**City of Fairhope
Planning Commission Agenda
5:00 PM
Council Chambers
April 1, 2019**

- A. ZC 19.04 Public hearing to consider the request of The Teachers' Retirement Systems of Alabama to establish initial zoning of Tourist Resort (TR) District conditional upon annexation into the City of Fairhope. The property is approximately 99.15 acres located south of Twin Beech Road and west of S. Section Street.
PPIN #: 5499, 20948, 63314, 286294

- B. SD 19.12 Public hearing to consider the request of The Teachers' Retirement Systems of Alabama for Preliminary Plat approval of Battles Trace, Phase 6, a 45-lot subdivision. The property is located on the west side of S. Section Street approximately 1/2 mile north of Battles Road.
PPIN #: 20948 and 63314

BOUNDARY & TOPOGRAPHIC SURVEY

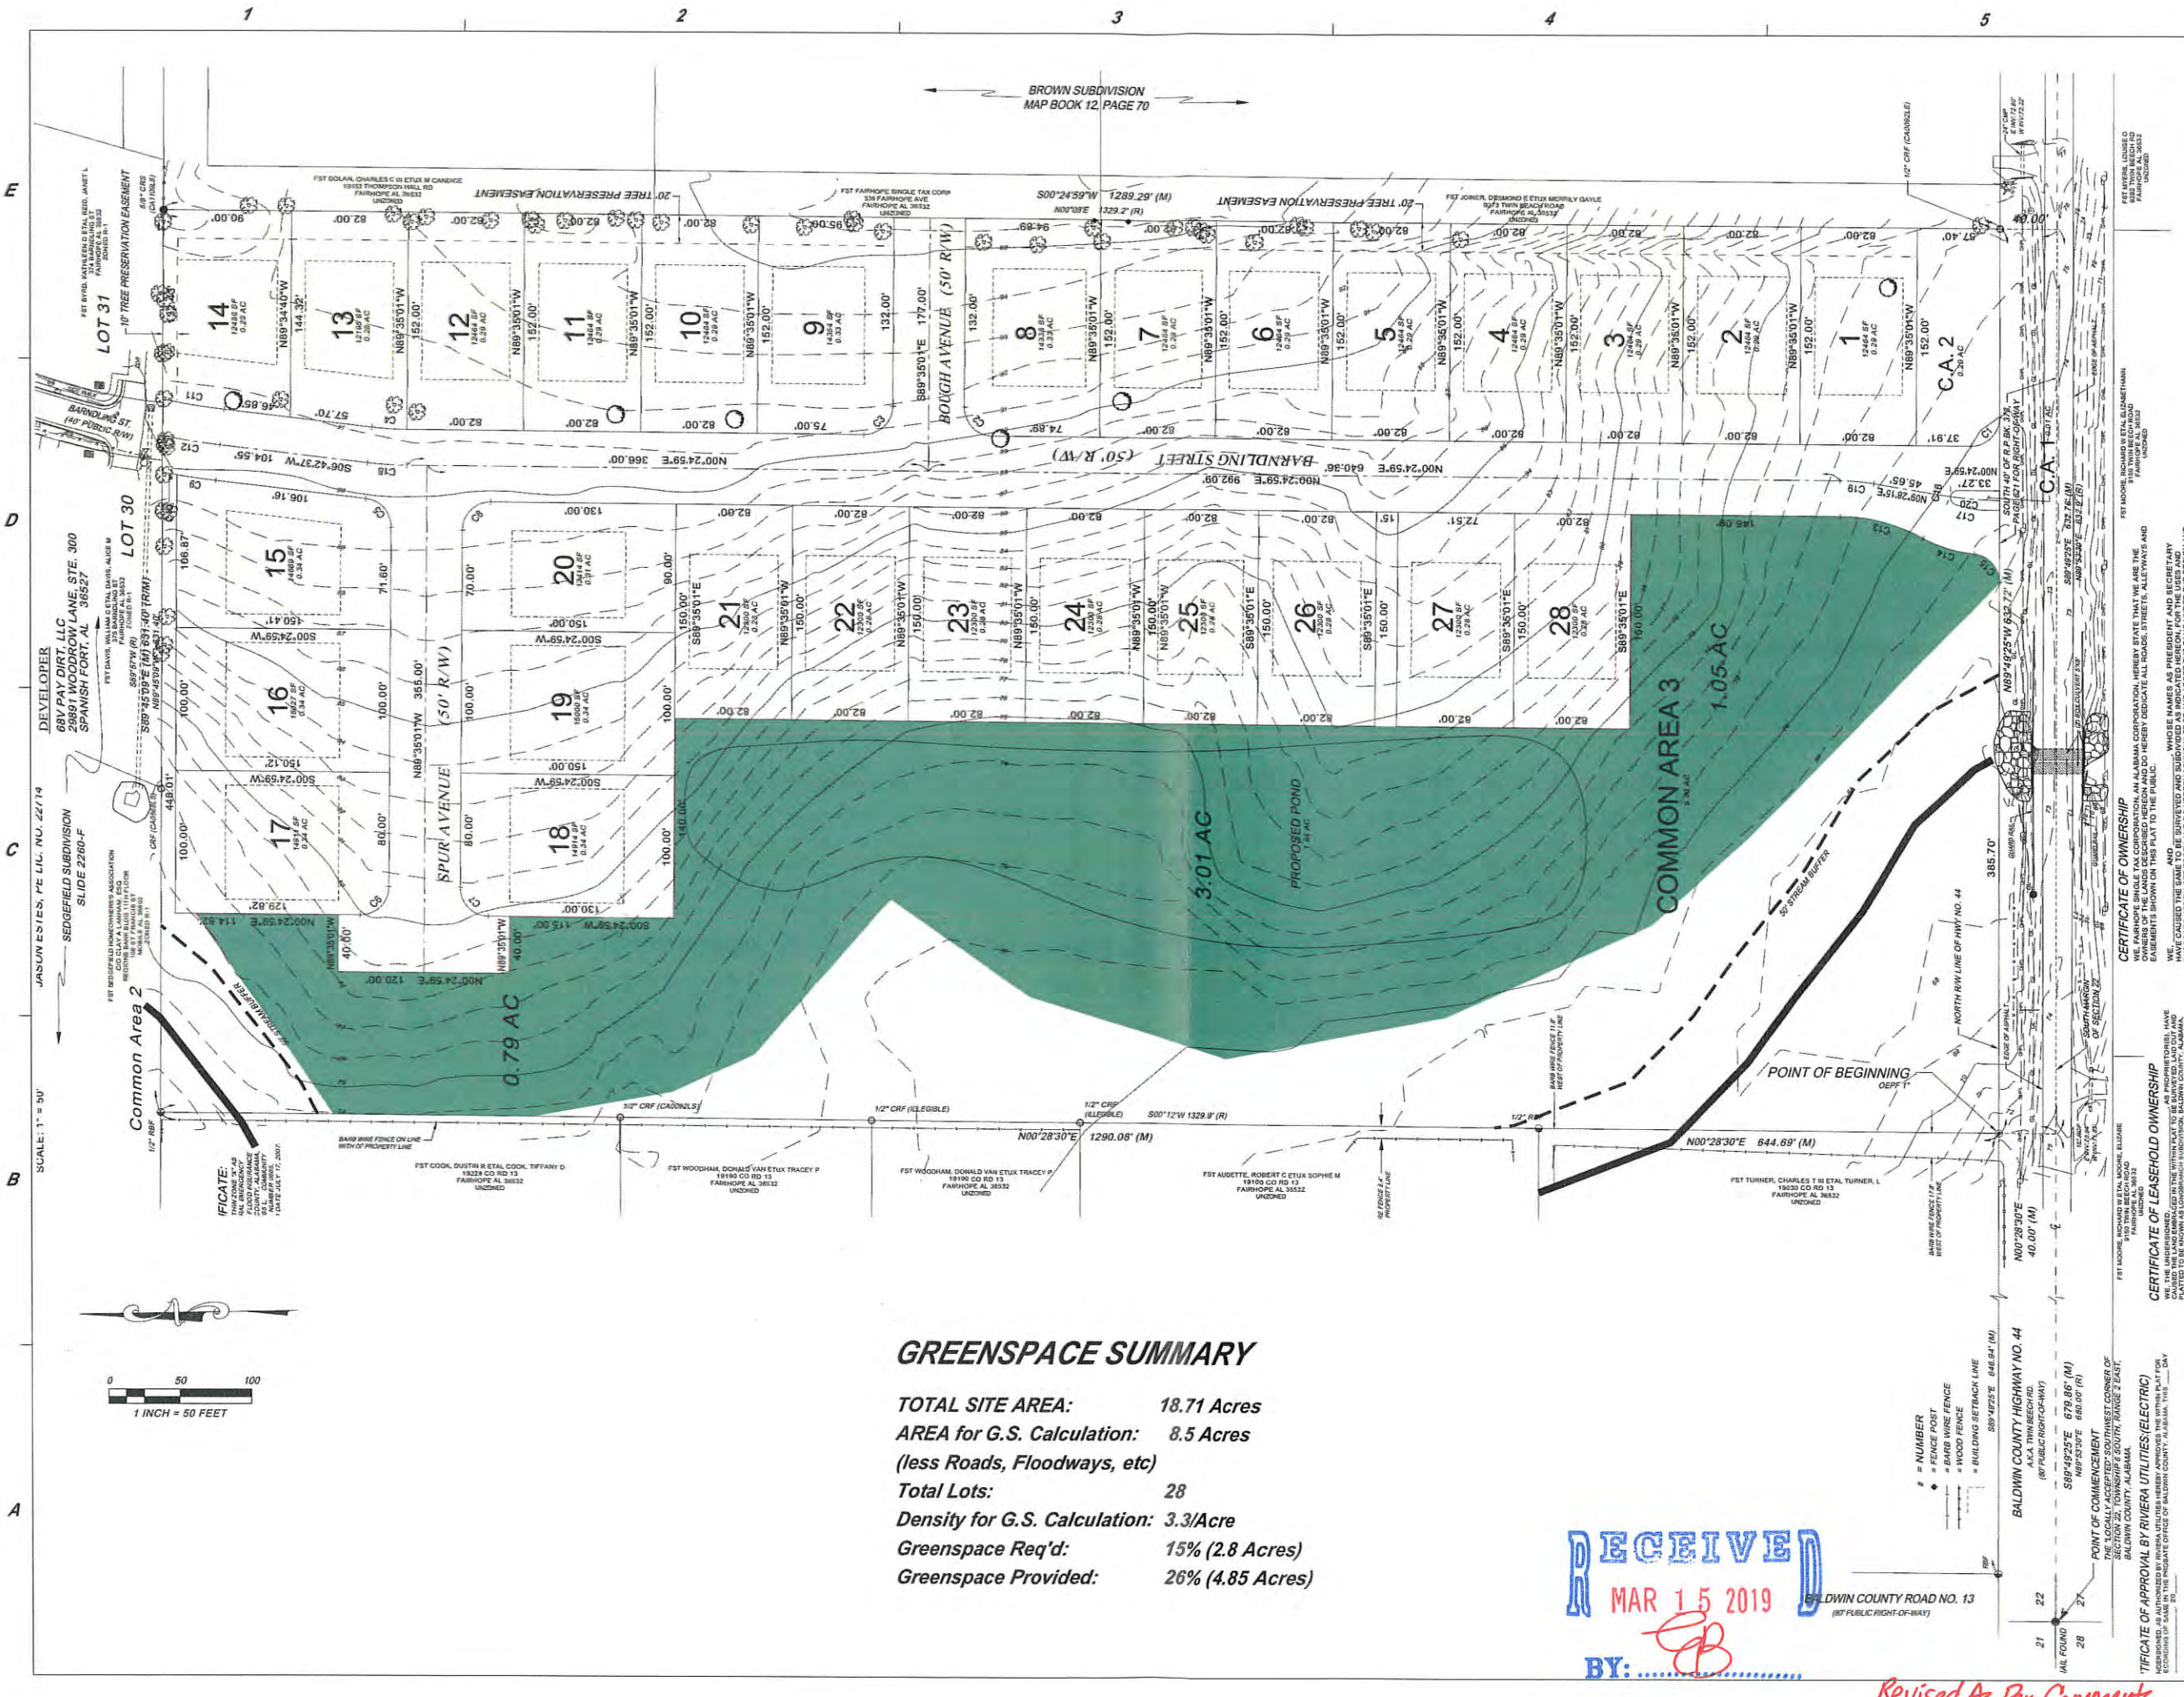
The applicant shall identify any natural features of the site, including, but not limited to wetlands, tributaries, streams, and natural drainage features. All required buffers and signage shall required as per the City of Fairhope Subdivision Regulations (Article V Section F, Stream Buffers. The applicant has identified the stream buffer and has added the buffer signage on sheets C2 and C5 on the construction drawings. Notes have been added to the Plat regarding the buffer but did not specify the regulation and allowed uses within stream buffers.

The applicant has added notes to the construction drawings (B2 and D1) stating that red soil and clay is not allowed within 100’ of critical areas, including wetlands and streams.

Silt fences shown on the Best Management Plan (Sheet C2) shall be Type A. The applicant has corrected sheet C2 to show Type A silt fences.

On Page D-1, Pond Construction, the applicant shall note that red soils and clay are not allowed in pond construction. The applicant has added the note to sheet D-1.

Staff asked if the applicant explored saving the tree at the intersection between the neighborhoods. Staff also requested the applicant provide a preservation buffer for the trees along the back of lots from lot 4-14 with a note on the plat that trees shall not be removed unless they are dead, dying or show the presence of termites. The applicant added a note that "no trees shall be removed from within the said preservation easement unless approved by the City of Fairhope." The applicant states "We did look at the tree at the intersection of the neighborhoods and concluded it could not be saved. Sidewalks have been routed around live oaks at the neighborhood intersection. A 10' tree preservation easement has been added to the north side of lot 14. Also a 20' tree preservation easement has been added to the east boundary of the property."

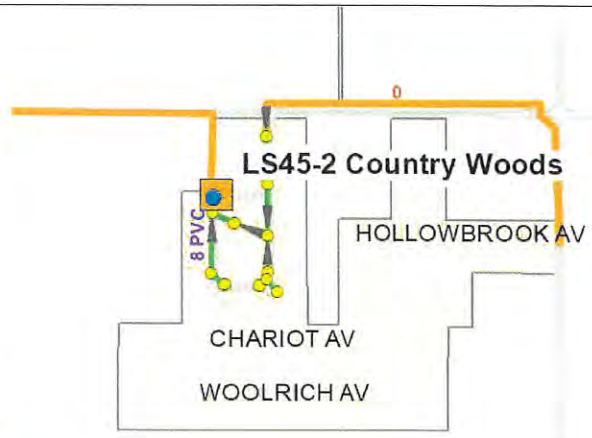
Comments: Three grinder pumps are depicted on drawing C04, and as a result a low-pressure request procedure is triggered. Please submit the application within Standard Specifications for Constructing Sanitary Sewer Facilities and Water Facilities and include the appropriate sections requesting the use of low-pressure if it is the desire of the applicant to utilize low pressure sewer on subject property. FPU sanitary sewer is available in the vicinity of subject property as seen in the map excerpt below:

EOR verified via follow-up correspondence FPU intends to install sewer service in the HWY 181 ROW to service subject property. As a result, drawing C04 now reflects a plan view of a gravity sewer system brought to the edge of the HWY 181 ROW. Due to the gravity sewer's 6" pipe size a profile drawing is typically not included, and this review assumes any follow-up correspondence of a routine nature required for the sewer system will be submitted directly to FPU and reflected on as-built drawings.

SITE PLAN

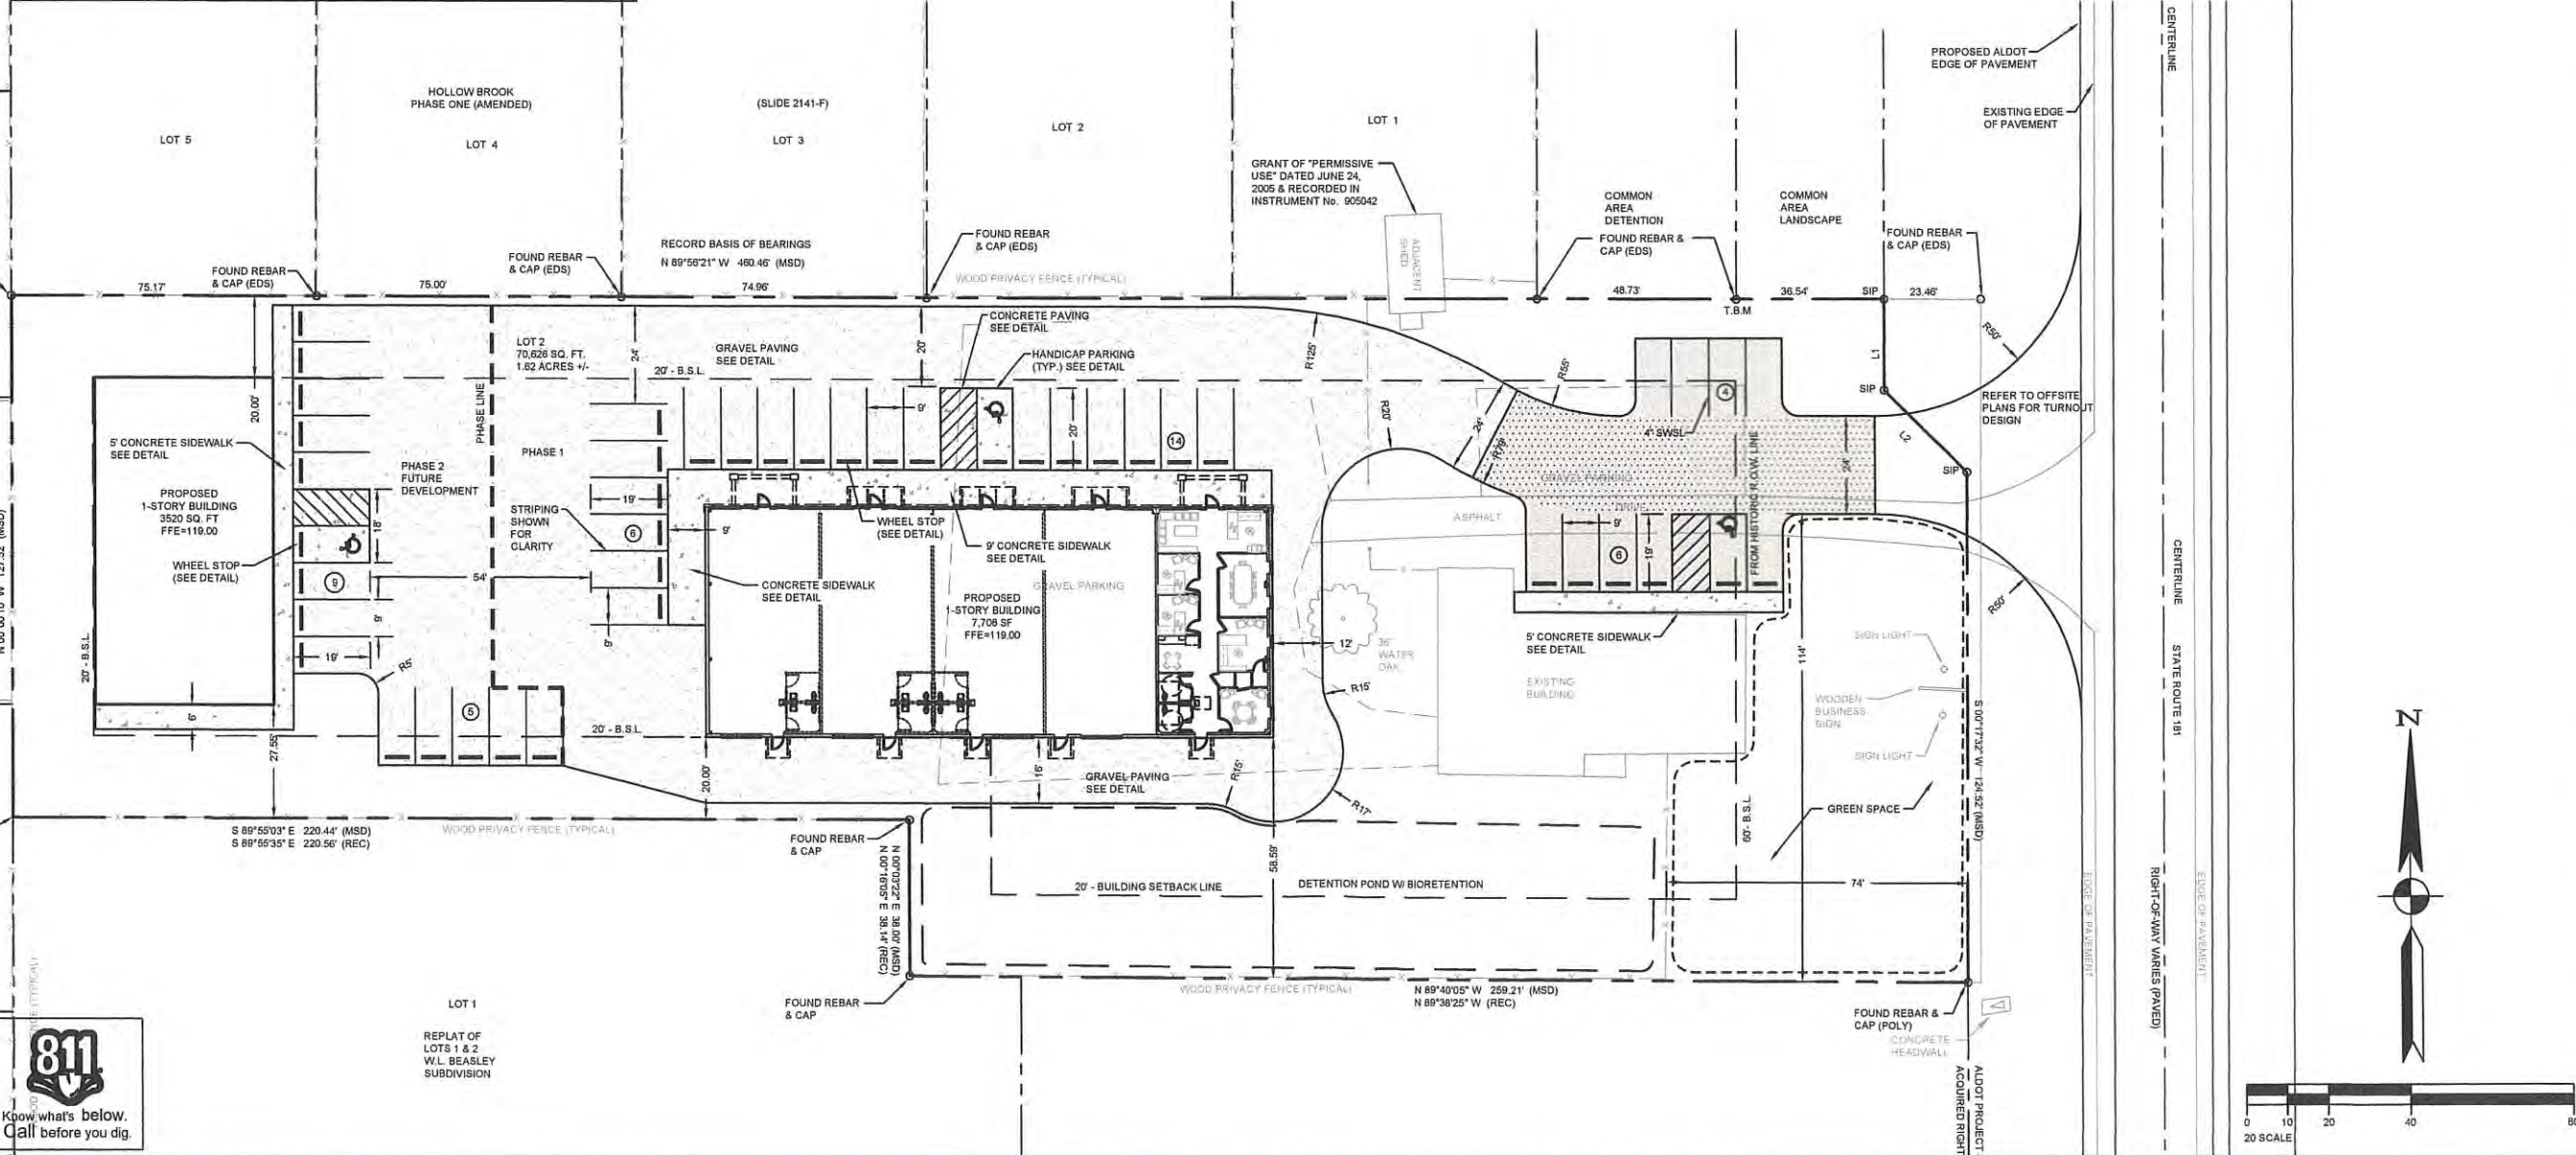
Comments: *Please revise and resubmit the land usage table on drawing C01 to reflect the amount of greenspace for the site as required by Article V, Section C3 through C7. Land Usage table has been modified to reflect greenspace amounts, drawing C01 and C02 identify greenspace locations. The 12.4% greenspace submitted is in compliance with this section, however, see Article V, Section C.4 for conditions of approval.*

Comments: Please revise and resubmit the land usage table on drawing C01 to reflect the amount of greenspace for the site and in compliance with this section. Note that HWY 181 is a minor arterial and greenspace may not be located adjacent to arterial or collector streets. Land Usage table has been modified to reflect greenspace amounts, drawing C01 and C02 identify greenspace locations. The EOR requested clarification of the amendments to the greenspace requirements as included in Resolution 2019-01, specifically related to item "e" above. Item "e" was not amended by Resolution 2019-01, and as a result a portion of the greenspace indicated on drawing C01 and C02 is adjacent to the AL HWY 181 ROW. It appears sufficient space exists so that if an area wide enough for a sidewalk or pedestrian easement is removed from the area adjacent to the ROW, the remaining greenspace will comply with the 10% required by Article IV, Section C2. An excerpt of Resolution 2019-01 is below:

As a condition of approval, please amend the greenspace depicted on drawings C01 and C02 to reflect greenspace not adjacent to the AL HWY 181, and include the amended greenspace drawings in the required as-builts plans.

Comments: Drawing C04, utility plan, does not reflect placing existing and proposed overhead electrical power underground. Drawing C04 has been revised to reflect the two proposed buildings with underground electrical service. This review assumes the existing building with overhead power will be converted to underground electrical service at the next routine upgrade or disconnection of service.

- 5) Article V, Section C.4. *Greenspace Design Requirements*
 - a. Please amend the greenspace depicted on drawings C01 and C02 to reflect greenspace not adjacent to the AL HWY 181, and include the amended greenspace drawings in the “for construction” as well as the required as-builts plans.

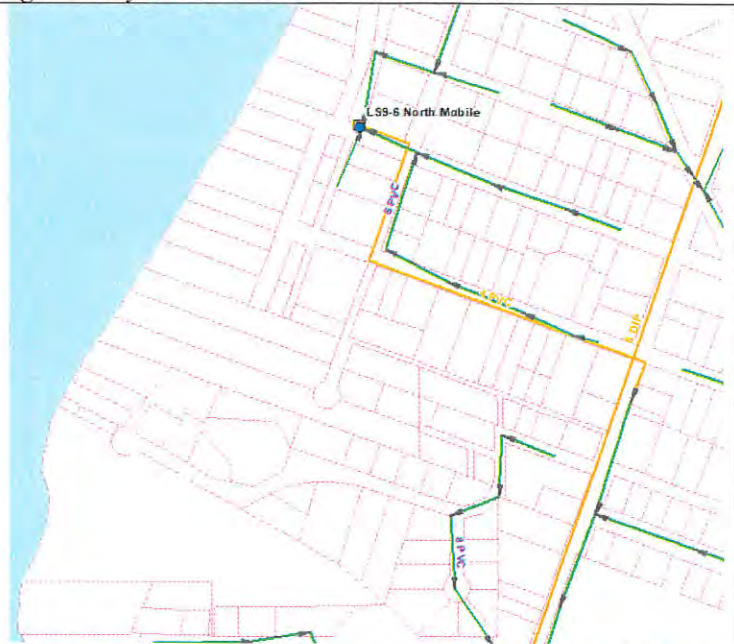
Comments: Sanitary sewer service is available in the vicinity of subject property, as seen in the sewer map excerpt at right. Construction of a main extension will be necessary to provide service to subject property – please provide plans and profiles of the main extension as a component of the follow-up submittal. Further, please include the application required within Standard Specifications for Constructing Sanitary Sewer Facilities and Water Facilities.

The applicant provided correspondence indicating the applicant conferred with Fairhope Public Utilities (FPU) Director of Operations Richard Peterson, and indicated Mr. Peterson does not require the application within *Standard Specifications for Constructing Sanitary Sewer Facilities and Water Facilities* as indicated above. The applicant states FPU will bring services to the requested lots via aid-to-construction fees (or direct invoice) and included this note on the preliminary plat. A final plat process is required so that City of Fairhope approval of the improvements is approved by appropriate staff.
